June 2, 2025

ADDENDUM #1
BID NUMBER: 24-11

ESPLANADE BUILDING 4 ELEVATOR ADDITION

STAGING PLAN

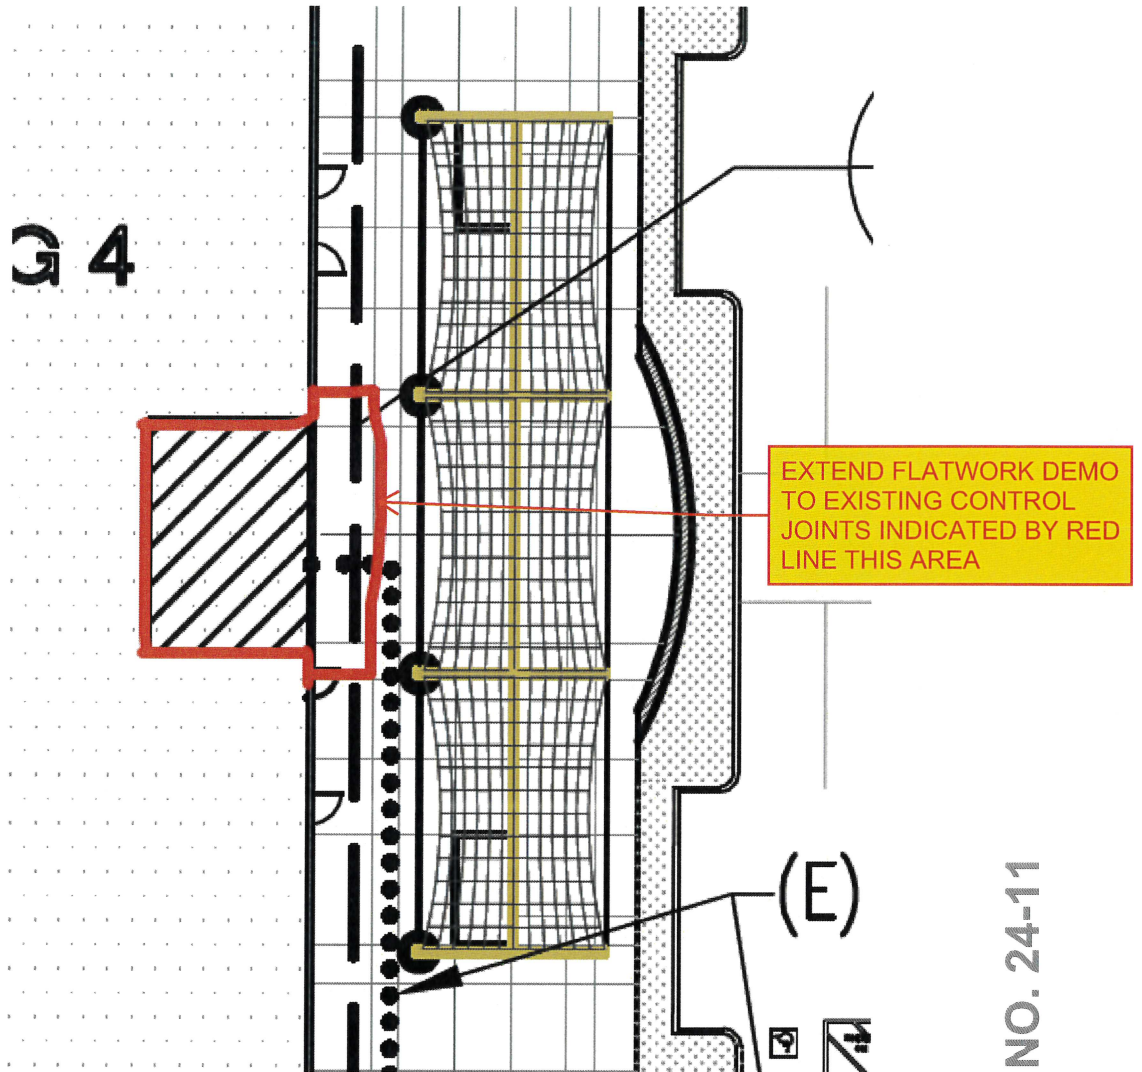
11. Staging Area: See attached Staging Plan sketch for contractor's layout area on site.
